City of Mount Vernon Comprehensive Sewer Plan Amendment

April 2004

Subject: Comprehensive Sewer Plan Amendment

Project Number: 09637-006070

Figure 1: Amendment Option

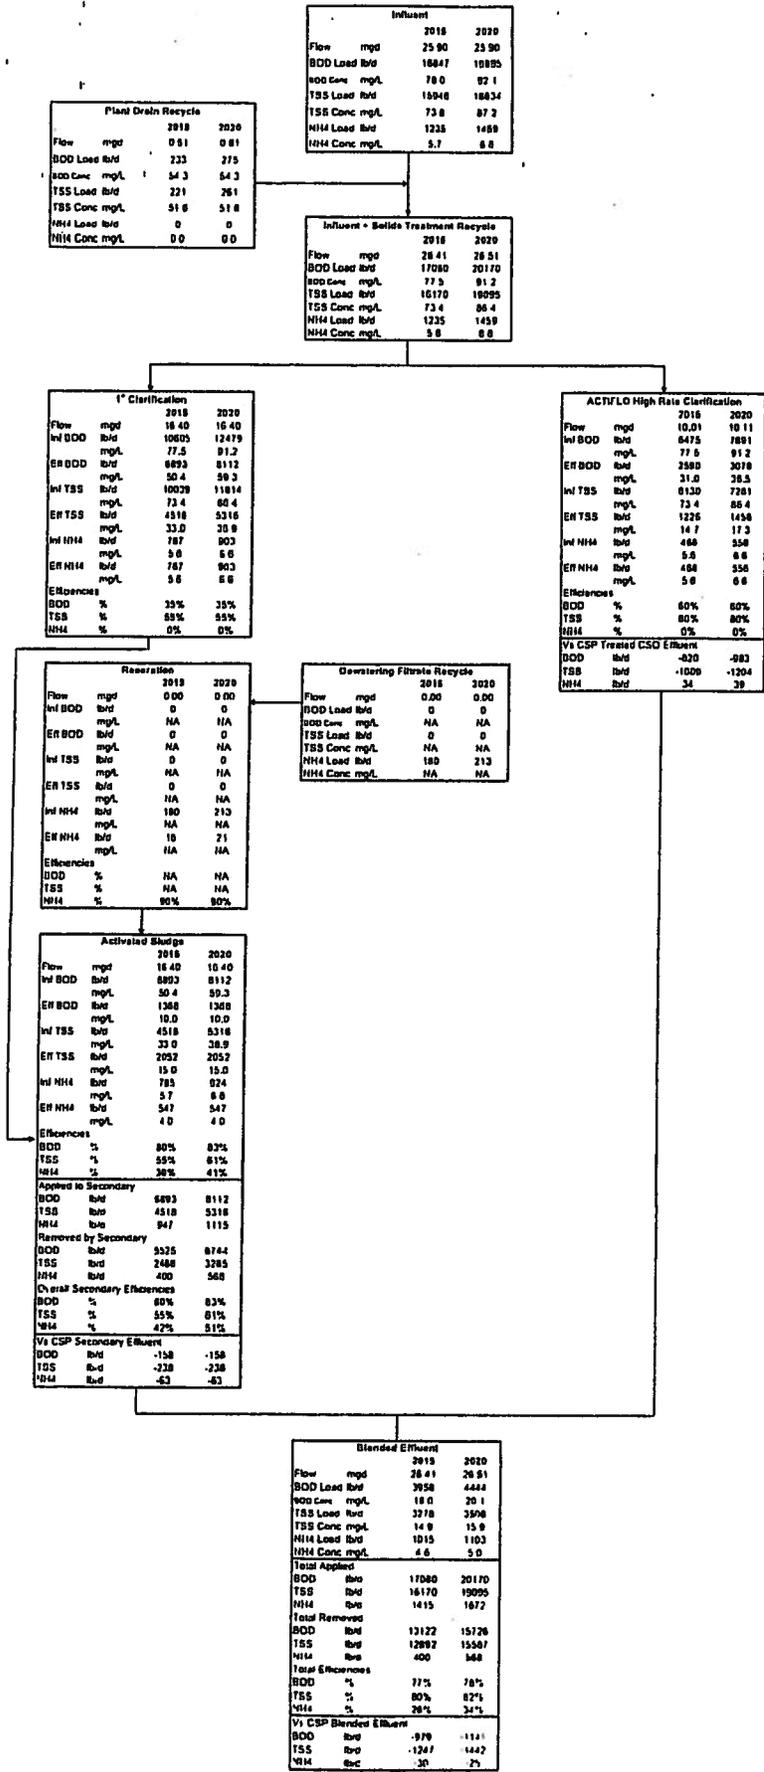
Mass balances were prepared based on the results of the BIOWIN computer simulations. The mass balances compared the amount of projected pollutants discharged into the Skagit River by: (a) the CSP-proposed treatment scheme, and (b) the modified treatment scheme proposed in the CSP amendment. The years compared were 2005, 2010, 2015, and 2020. The revised flow projection indicates that re-routing of excess peak flow around primary treatment units and the secondary biological treatment unit would occur under the peak hour flow scenarios in 2015 and 2020. Results of mass balances for these two scenarios for both treatment schemes are presented in Figure 1 and Figure 2.

As shown in Figure 1 and Figure 2, the amendment treatment scheme is anticipated to discharge significantly lower BOD (979 lb/d in 2015 and 1,141 lb/d in 2020) and TSS (1,247 lb/d and 1,442 lb/d in 2020) loadings, and a similar amount (within 30 lb/d difference in 2015 and 2020) of NH₄ loading into the Skagit River as compared with the CSP treatment scheme. The effluent qualities of either treatment scheme would satisfy the anticipated future National Pollutant Discharge Elimination System (NPDES) requirement. However, the amendment treatment scheme would provide a net positive environmental benefit over the CSP treatment scheme based on the results of the mass balance analyses.
